BECHTEL CORPORATION LOS ANGELES	
SACRAMENTO MUNICIPAL UTILITY DISTRICT BANCROFT SEC. NUCLEAR STATION - UNIT 1	
TURBINE BUILDING AREA 9 CONDUIT & TRAY ARRANGEMENT PLAN AT GROUND FLOOR	
DATE 11/15/79	BY E-747

CMUD DRAWING CHANGE NOTICE	ECN No. A-2742/E TASK 575	IS INSP. REQ'D YES ☒ NO ☐	PREPARED BY TASK 575 11/15/79 RES 9/24/80	CHK'D BY 41	DRAWING NUMBER E-747	REVISION 14 ABA915
	FOR ECC USE ONLY DWS. REV. BY. DATE SHEET 1 OF 1

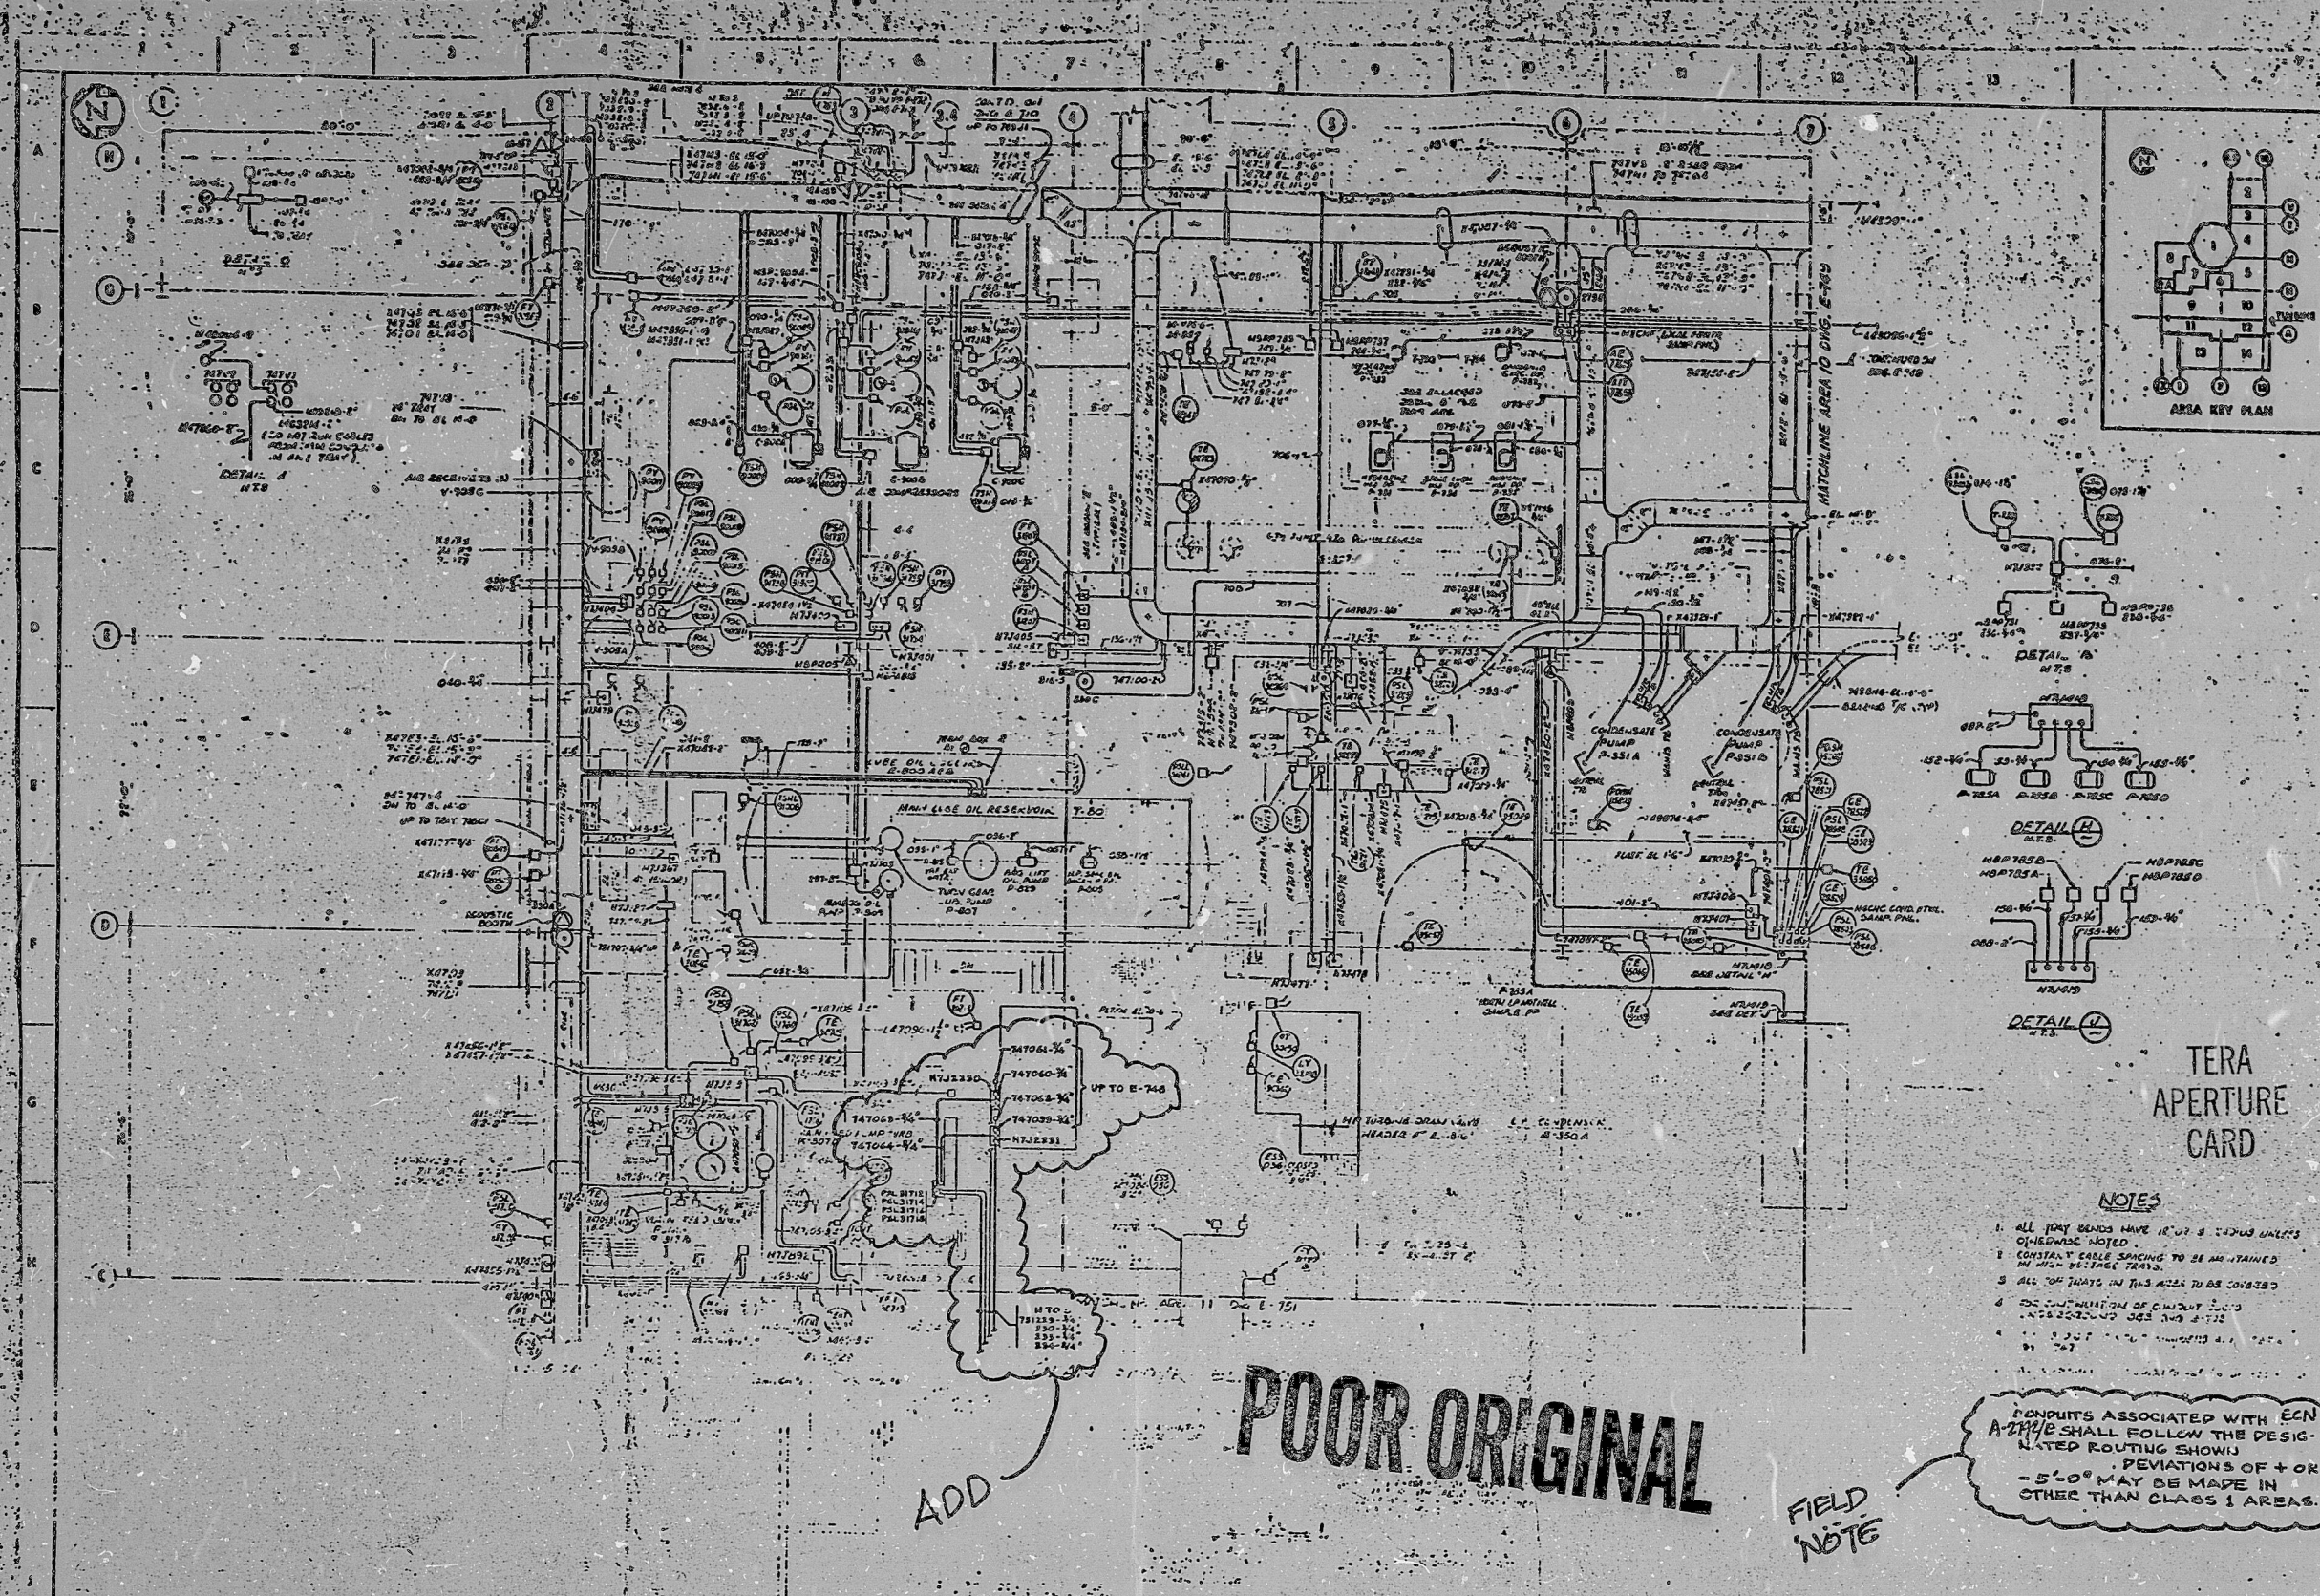
CONDUITS ASSOCIATED WITH ECN A-2742/E SHALL FOLLOW THE DESIGNATED ROUTING SHOWN. DEVIATIONS OF + OR - 5" MAY BE MADE IN OTHER THAN CLASS 1 AREAS.
